# Technical Information Bulletin

## RAF-11 s/n: L1026 and prior

Update of transorbs to diodes for the reception and paper feed roller.

## Diode

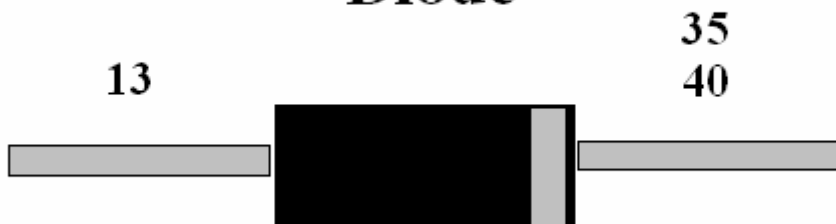
This update reduces the possibility of PLC failure and is strongly recommended by PDI. Part number 001298 Quantity 2.

Paper feed roller has the cathode to wire number 35 and the anode to wire number 13.

Reception solenoid / lateral jogger solenoid attach cathode to wire number 40 and anode to wire number 13 in the location shown in the picture.

Install diodes in locations shown in the following pictures.
